NUCLEAR REGULATORY COMMISSION

Title: Advisory Committee on Reactor Safeguards
Future Plant Designs Subcommittee

Date: Tuesday, April 9, 2013

MHTGR Reactor Building Vent Path from Reactor or Steam Generator Cavities

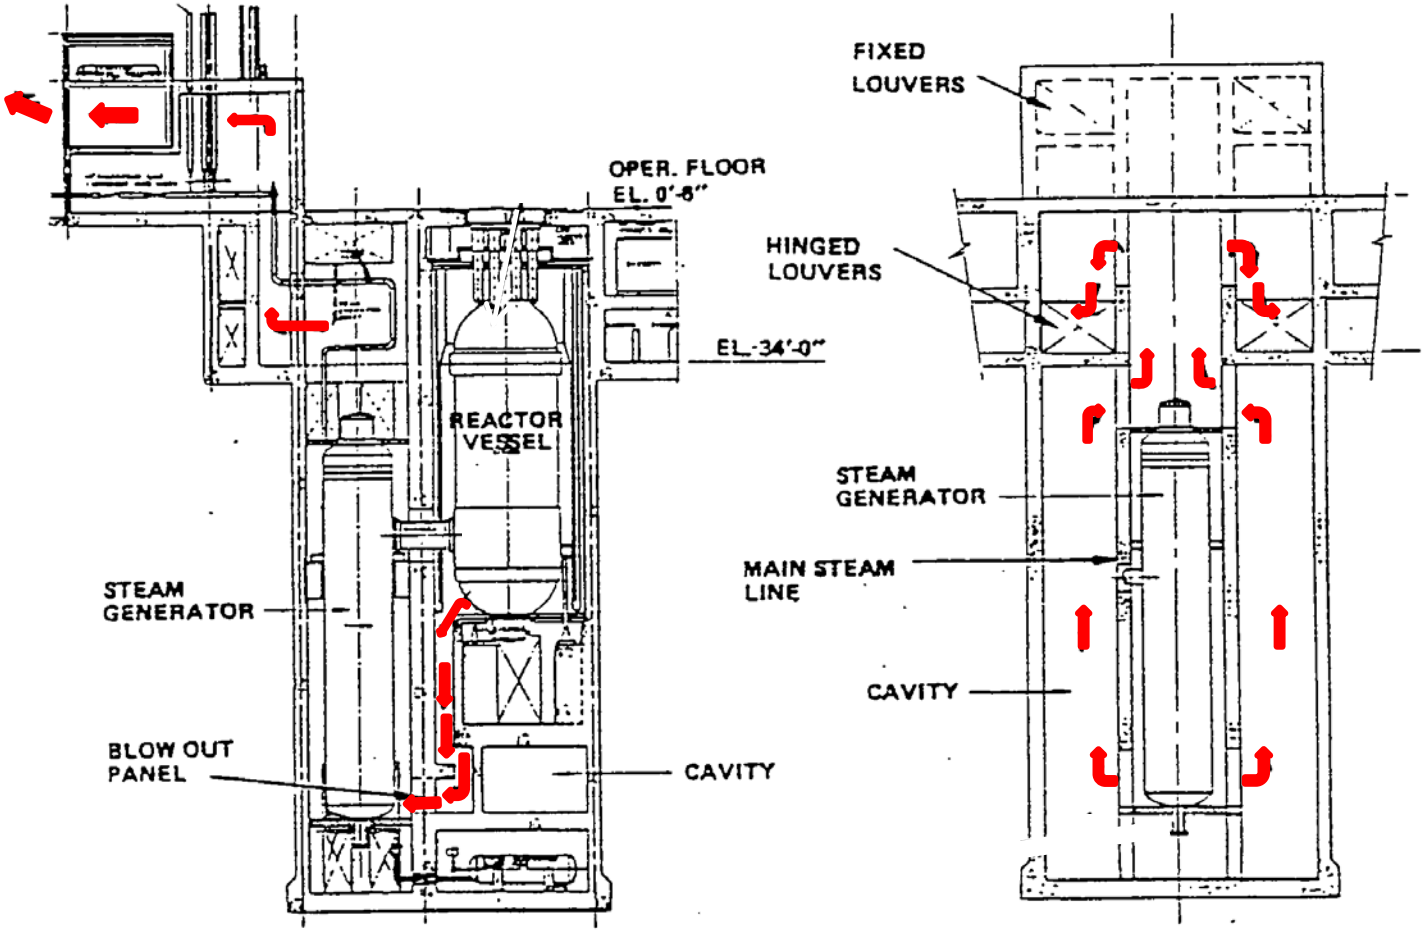
MEMBER CORRADINI: And sorry. So to bring us back up to date now 25 years later or whatever it is, the concern about having dust reside in little nooks and crannies and that dust having radionuclides with it, does it change that conclusion? About dust transport during this. In other words, it's not just in the active -- it's not just in the pressurized helium but it's also in stuff that has eroded away from the graphite that's sitting in nooks and crannies that wouldn't have been cleaned up during the active

MEMBER CORRADINI: Okay. The reason I'm asking the question is I've attended enough of the workshops that that answer tracks with what I've heard. But what I'm trying to get at is the uncertainty issue which is if I understand the system operation you're continually cleaning up the helium such that if God forbid you have an event like this there's not a lot of resident radionuclides.

MEMBER CORRADINI: That I'm well aware of from other dealings. I'm well aware of that. On the other hand, all of those pieces of physics are tough to estimate. So I'm trying to understand if I had to draw an uncertainty bound on this, a range, that all the things that was concluded back in `86 still maintain even with the uncertainty you might get from it. That's why I'm asking the question. With prismatic. Let's not go back to pebble for the moment.

MEMBER CORRADINI: Okay. So last question, then I'll stop. Is there anything from a testing or periodic maintenance approach to this that one could check to see that you don't have a buildup. Because I'm still -- I have this worry about this. And so if I can't be sure, and I have an uncertainty, is there something in periodic testing or maintenance that one can check this out?

A couple of things to note. On the figure on the left at the top where it says "Operating floor elevation 6 inches," that's where grade is. So most of this reactor building is below grade.

All Alternative Reactor Buildings Considered for MHTGR Met the TLRC with Substantial Margin

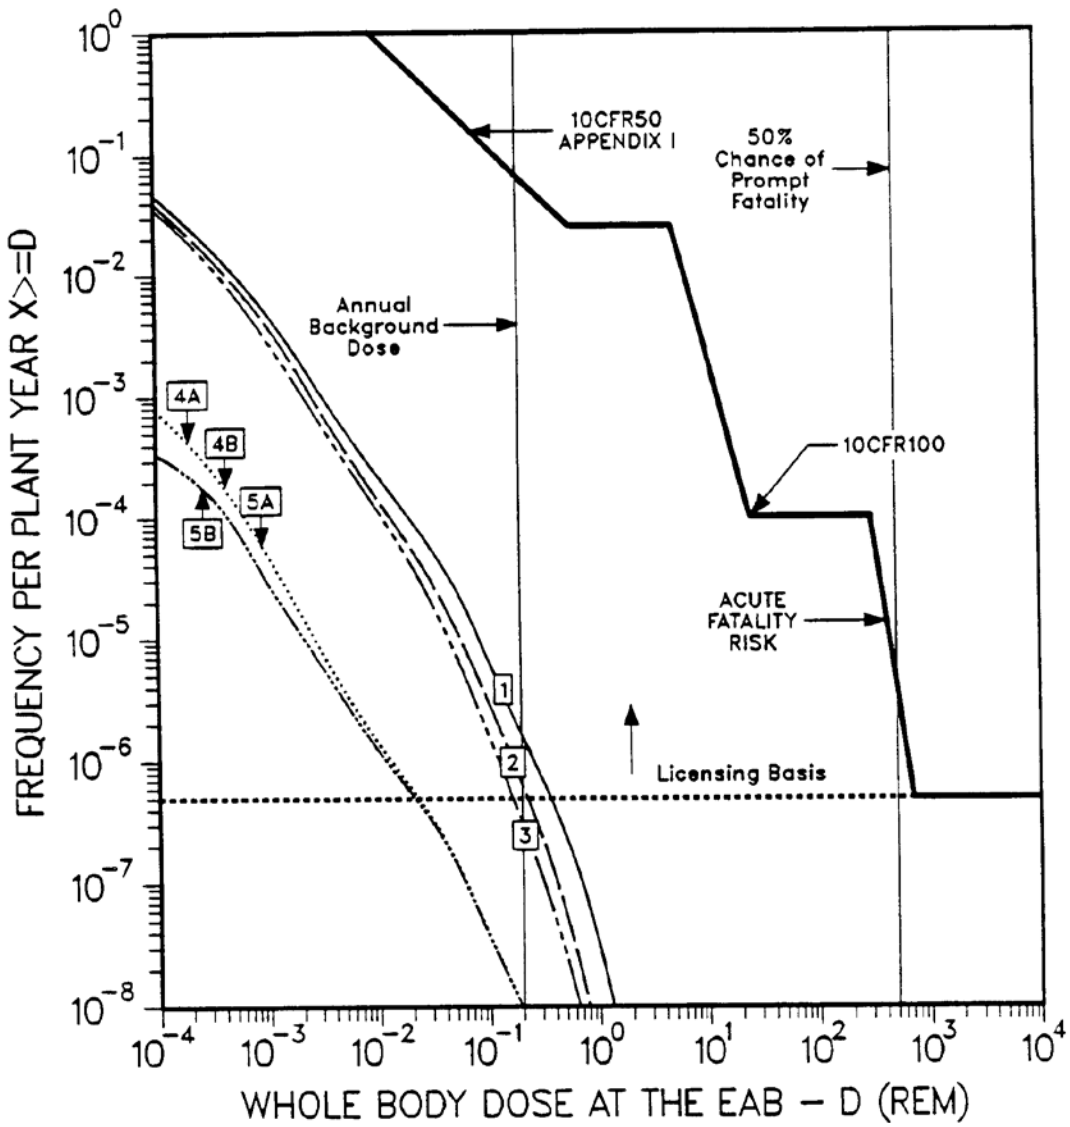
MEMBER CORRADINI: So I don't understand 4A and B. What does the air -- or the water RCCS do that 4A and B is different than 5A and B? Maybe I'm confused. Is it just the air and the water RCCS change the pressure?

MEMBER CORRADINI: So that means what? I'm sorry that -- I'm looking at the same time to see if we have this 88.311 that I can look in detail. I'm sure we've got it somewhere.

You can see that the alternatives where one adds filters to the vents really didn't make much of a change in terms of offsite dose.

MR. ALBERSTEIN: For the whole body. For the alternatives that have lower leak rates and higher volumes to result in lower pressure you did gain quite a bit on dose but you're gaining it relative to a point at which you weren't going much over background doses to begin with. So that raises the questions of adequate protection versus perfect protection for the public and whether an investment of resources to go to design alternatives such as numbers four and five are really buying anything of substance in terms of protection of public health and safety.

MHTGR DBEs, DBAs, and BDBEs (aka EPBEs) on F-C Plot *(circa 1987)*

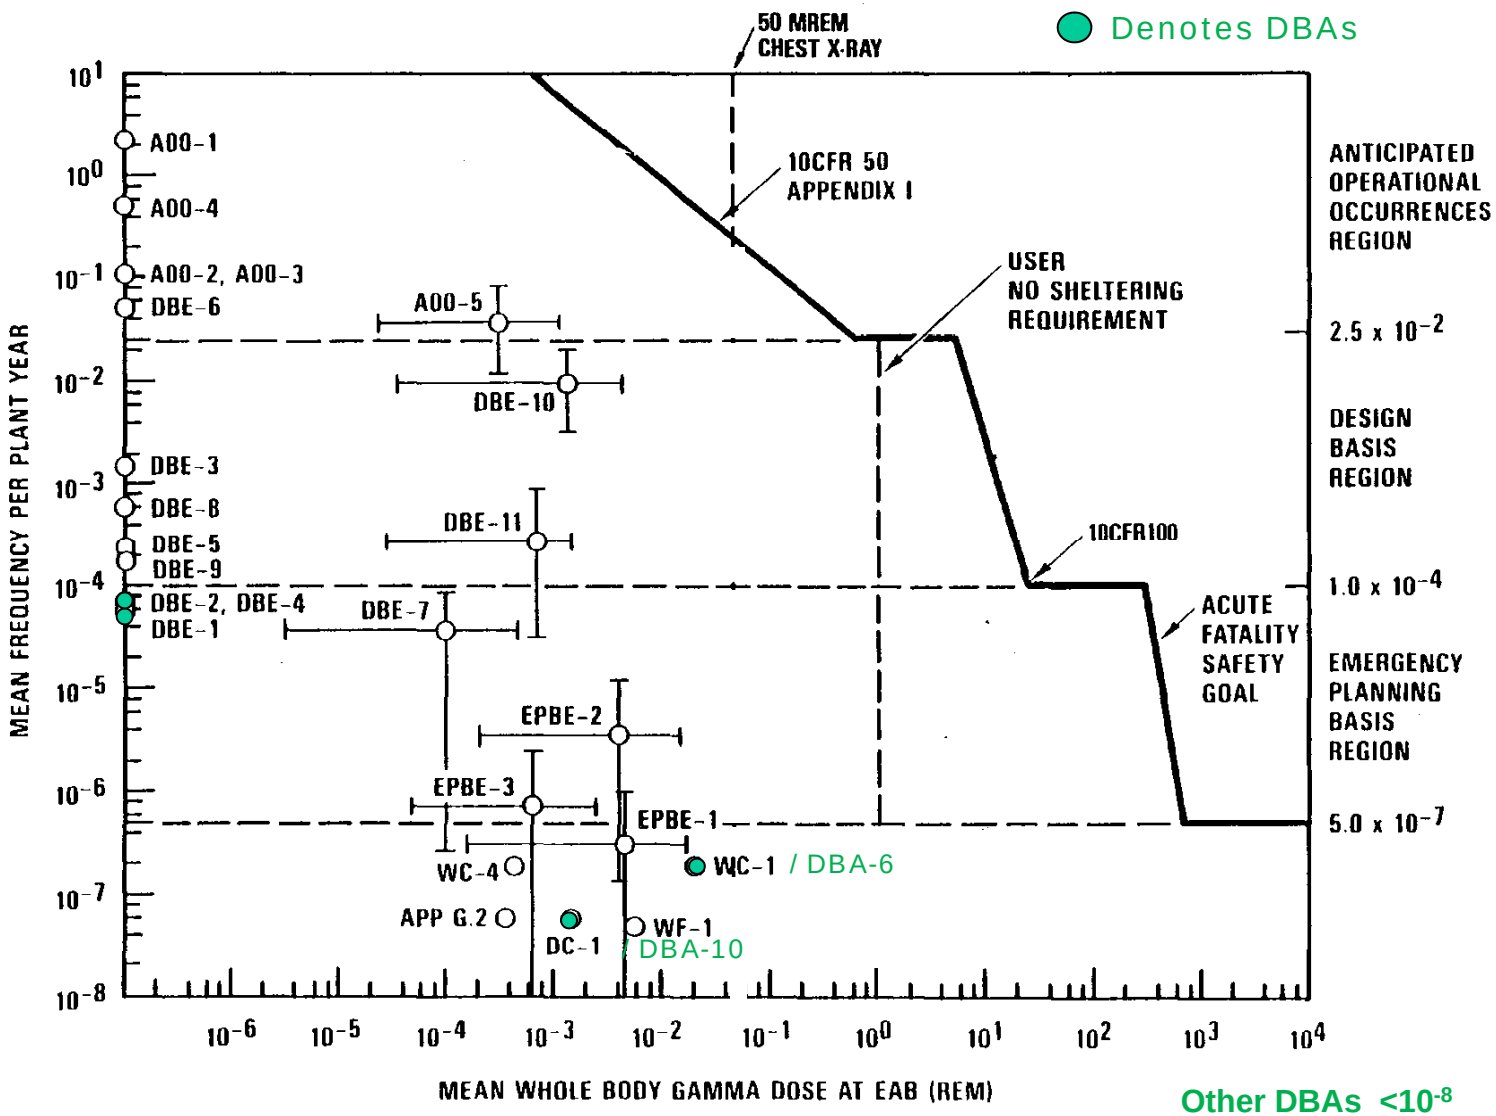
MEMBER STETKAR: I wasn't here in January so perhaps you covered some of this, but as I read through it I had some confusion about the notion that you just described. You said that the DBAs are derived from the DBEs, assuming that only safety-related systems are available. Is that correct?

DR. KRESS: Let me ask you a question about that. When you look at an SSC in one of these events and look at the uncertainties associated with it to see if it might move you into another frequency

MR. SILADY: And we had already started to talk a little bit about design basis accidents as well as design basis events and how the design basis accidents only have safety-related SSCs. Originally this plot was just of the first three categories of LBEs. They were called anticipated operational occurrences. They were called design basis events as they are now. And they were called emergency planning basis events back then where now we're calling them

meet the NRC safety goals, below 5 times 10^{-7}. And there are some that don't even show up on this plot that goes down to 10^{-8}.
